**California MLPA Master Plan Science Advisory Team**  
**Summary of SAT Water and Sediment Quality Evaluation of Round 3**  
**SCRSG MPA Proposals for the MLPA South Coast Study Region**  
*(Draft revised October 7, 2009)*

**Overview of MPA Proposal Evaluations Regarding Water and Sediment Quality**

**Figure 1. Number of coastal MPAs co-located with ASBS, with Northern Channel Islands (NCI) shown separately**

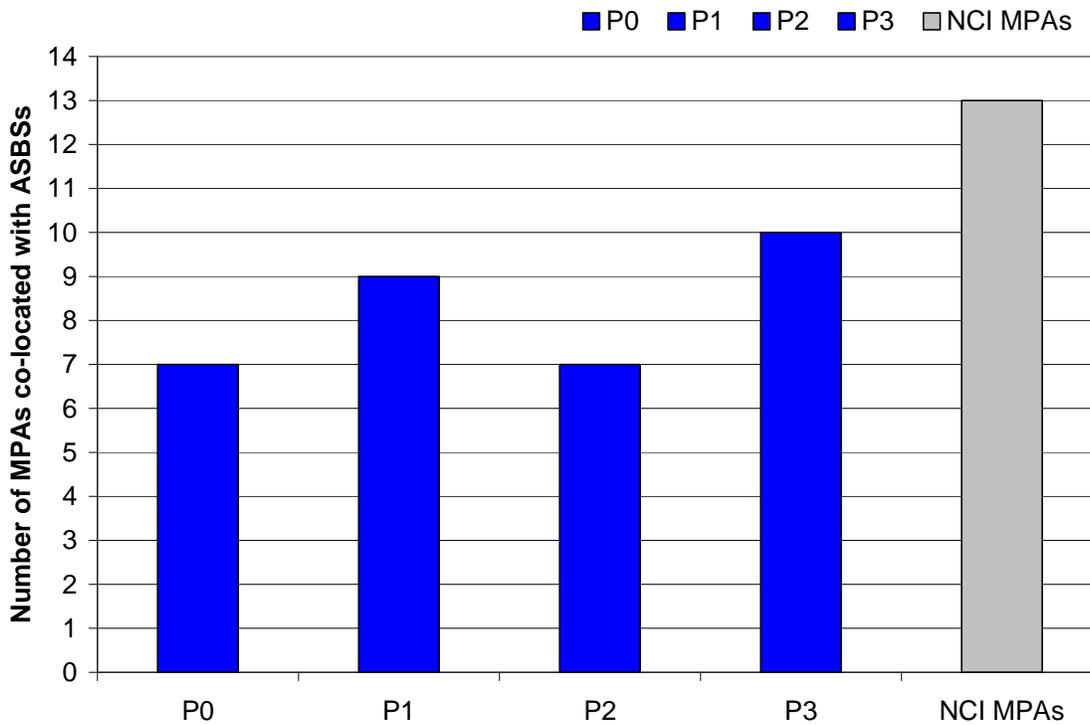
The inclusion of the 13 Northern Channel Islands (NCI) MPAs equally in all proposals helped to improve overall weighted scores due to co-location with large ASBSs at those island MPAs (Figure 1). In addition to being co-located with ASBSs, none of the NCI MPAs are co-located with areas of water-quality concern. Therefore all of the NCI MPAs receive the highest score of 1.0 (Table 1). Non-inclusive of the NCI MPAs, the various proposals included between 7 and 10 ASBSs in coastal<sup>1</sup> MPAs.

**Figure 2. Scores for all water-quality evaluation categories in a given proposal**

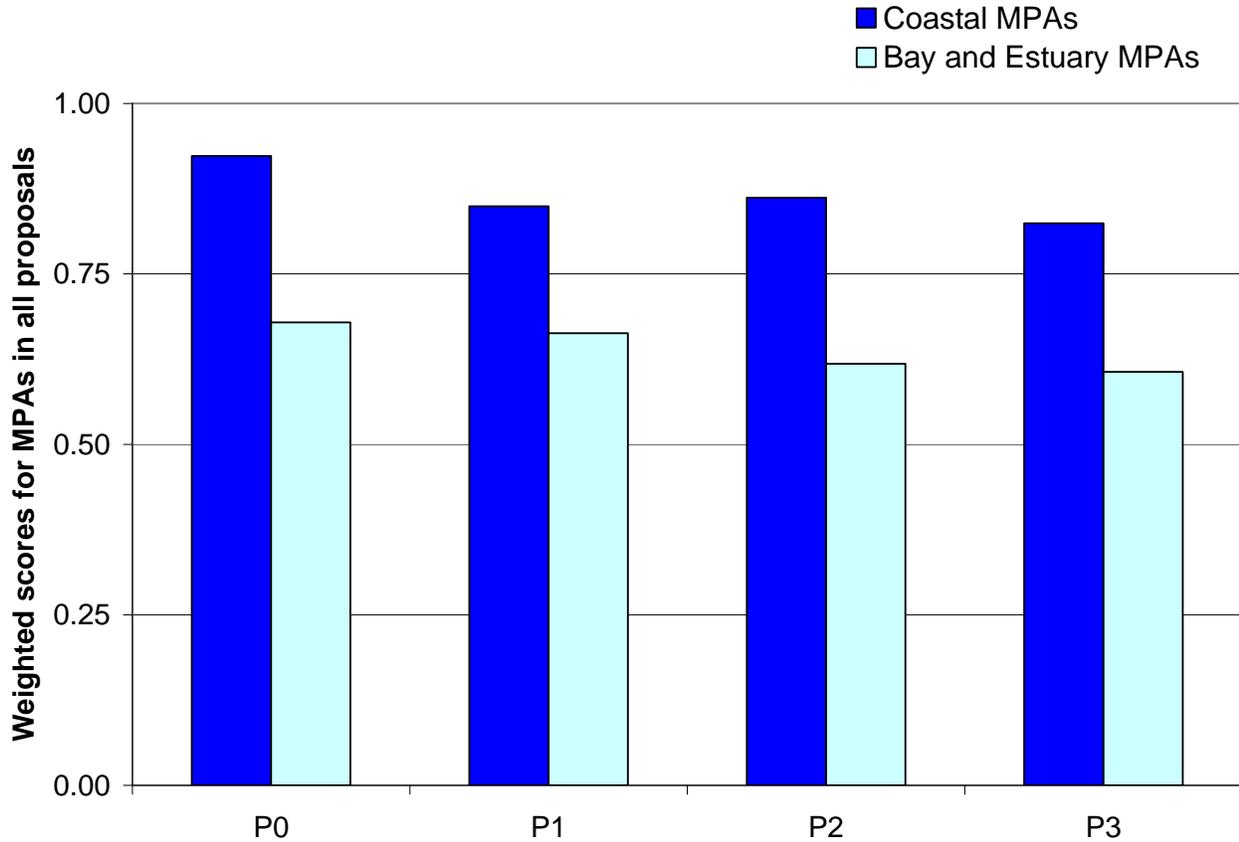
All proposals scored very well for coastal MPAs, with all proposal scores greater than 0.75 (Figure 2). The difference between the highest and lowest scores was negligible. Of the three proposals submitted for evaluation, Proposal 2 had the most favorable coastal MPAs scores followed by Proposal 1 and then Proposal 3, although the difference was very small.

**Figure 3. Weighted scores and the associated water-quality concerns for all Round 2 proposals**

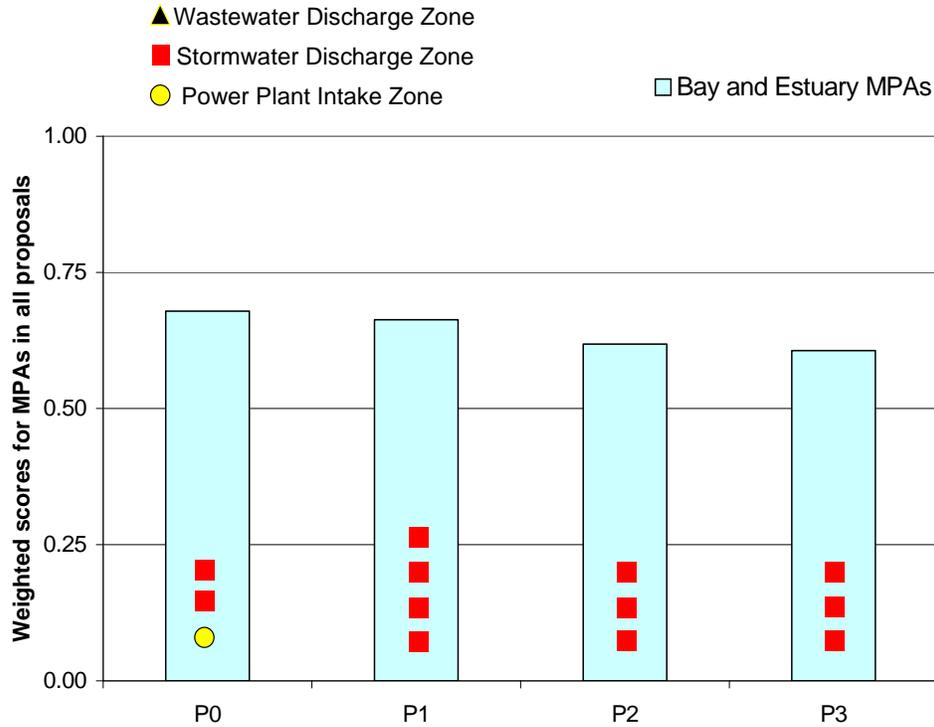
The bay and estuary MPAs scored lower than coastal MPAs for all proposals, with scores ranging from 0.61-0.66 (Figures 2 and 3). This was expected because of the reasons discussed above. All of the proposals included stormwater plumes in certain bay and estuary MPAs. Proposals 2 and 3 included the fewest major stormwater plumes in embayment MPAs, but scored lower overall than Proposal 1 because they included fewer embayment MPAs that are unaffected by stormwater plumes. It is important to state that all of the proposals did very well in excluding power plant intakes in bay and estuary MPAs. Overall, for bay and estuary MPAs, Proposal 1 had the best water-quality score, although the other two proposals also scored well. All three proposals improved on those of the previous round in avoiding water-quality concerns within bays and estuaries.

**Figure 4. Proposal 0: scores for coastal MPAs with water-quality concerns**

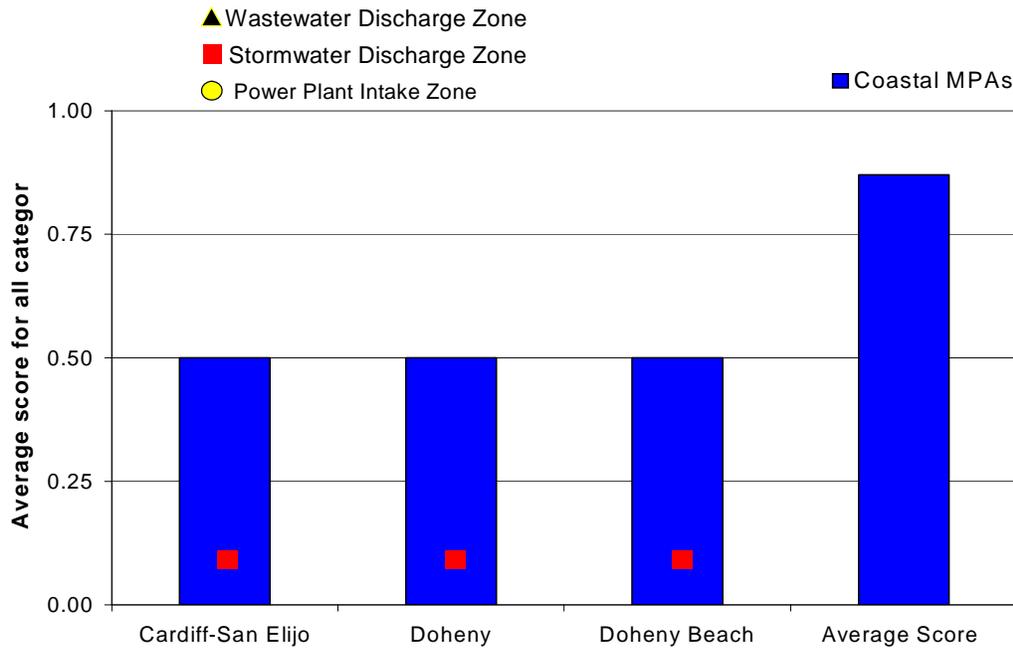
The average score for existing coastal MPAs is 0.87. Excluding the NCI, 19 out of 22 coastal MPAs (86%) scored 0.75 or higher. Also excluding the NCI, seven of 22 (32%) existing MPAs are co-located within ASBSs (Table 2). Only three out of 22 coastal MPAs scored lower than 0.75 (located within stormwater discharge plumes at San Juan and Escondido Creeks) (Figure 4).

**Figure 5. Proposal 1: Scores for coastal MPAs with water-quality concerns**

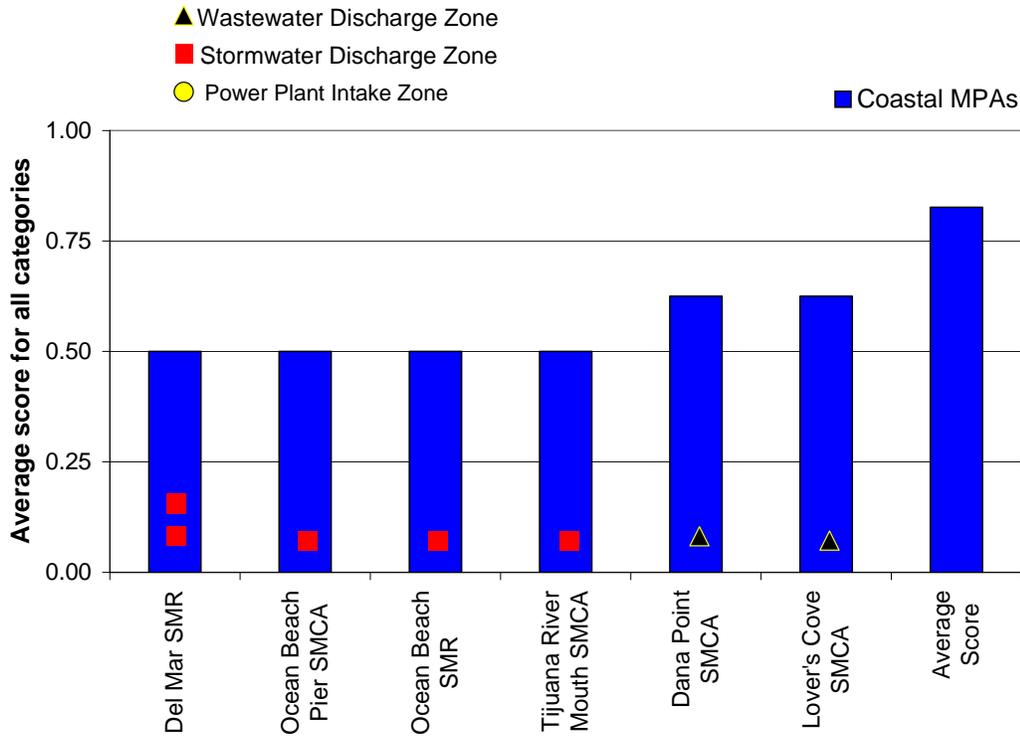
The average score for Proposal 1 coastal MPAs is 0.83 (Figure 5). Excluding the NCI, 23 out of 29 (79%) coastal MPAs scored 0.75 or higher. Excluding the NCI, 9 of 29 (31%) coastal MPAs are co-located within ASBSs (Table 3). There were six coastal MPAs that scored lower than 0.75. Four coastal MPAs (Del Mar SMR, Ocean Beach Pier SMCA, Ocean Beach SMR, and Tijuana River Mouth SMCA) received reduced scores because they were located within major stormwater discharge zones (San Dieguito and Peñasquitos Creeks, San Diego River, and Tijuana River respectively). Del Mar SMR was located within two stormwater discharge zones; the San Dieguito and Peñasquitos Creeks can be found on either side of this MPA. Two coastal MPAs (Lover’s Cove SMCA and Dana Point SMCA) received reduced scores because

each intersected an intermediate wastewater outfall’s quarter-mile buffer zone (Avalon outfall and Aliso Creek outfall, respectively). It is important to note that these two MPAs did not contain the entire outfall but slightly intersected the outer edge of the outfall’s buffer zone.

**Figure 6. Proposal 2. Scores for coastal MPAs with water-quality concerns and the proposal's average score**

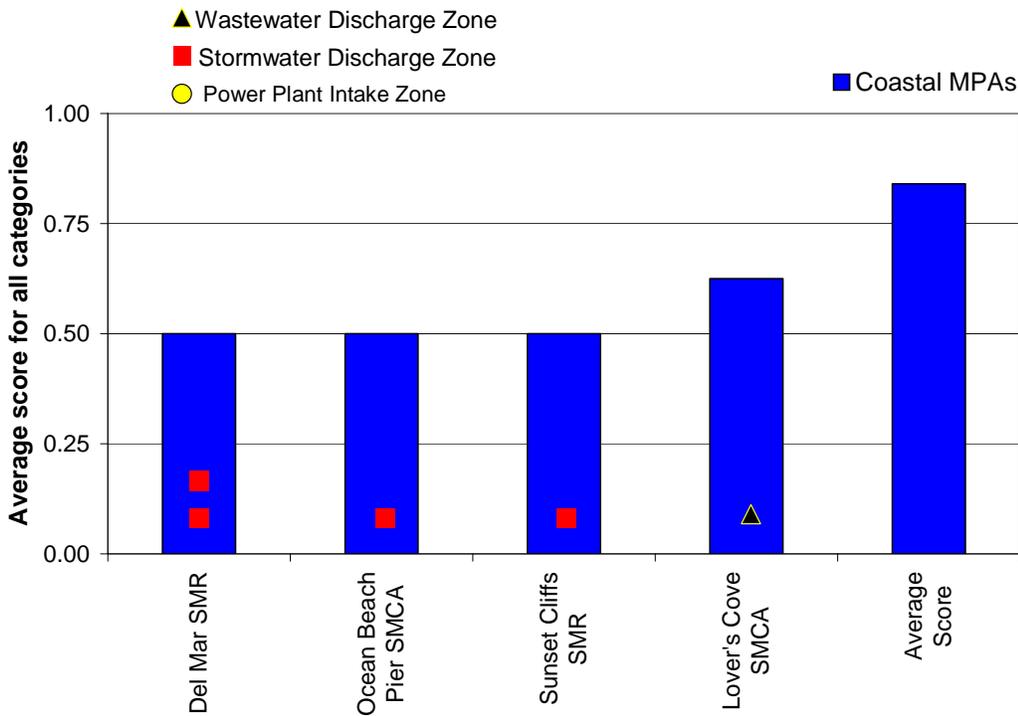
The average score for Proposal 2 coastal MPAs is 0.84 (Figure 6). Excluding the NCI, 17 out of 21 (81%) coastal MPAs scored 0.75 or higher. Excluding the NCI, 7 of 21 (33%) coastal MPAs are co-located within ASBSs (Table 3). There were four coastal MPAs that scored lower than 0.75. Three coastal MPAs (Del Mar SMR, Ocean Beach SMCA, and Sunset Cliffs SMR)

received reduced scores because they were located within major stormwater discharge zones (San Dieguito and Peñasquitos Creeks and San Diego River). One coastal MPA (Lover's Cove SMCA) is co-located with a wastewater discharge zone (Avalon outfall). This MPA slightly touches the outfall's quarter-mile buffer zone.

Figure 7. Proposal 3. Scores for coastal MPAs with water-quality concerns

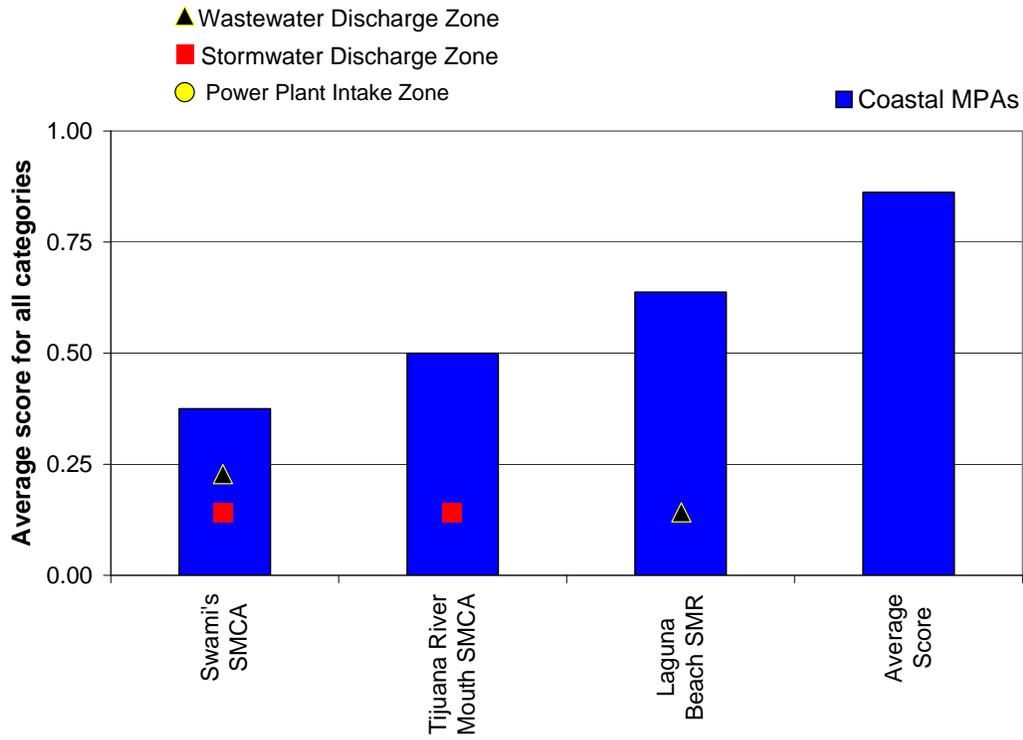
The average score for Proposal 3 coastal MPAs is 0.86 (Figure 7). Excluding the NCI, 20 out of 23 (87%) coastal MPAs scored 0.75 or higher. Excluding the NCI, 10 of 23 (43%) coastal MPAs are co-located within ASBSs (Table 3). There were three coastal MPAs that scored lower than 0.75. Two coastal MPAs (Swami's SMCA and Tijuana River Mouth SMCA) received reduced scores because they were located within major stormwater discharge zones (Escondido Creek and Tijuana River). Swami's SMCA is also co-located with a wastewater discharge zone (San Elijo outfall), while Laguna Beach SMR has a wastewater discharge zone completely contained within it (Aliso Creek outfall).
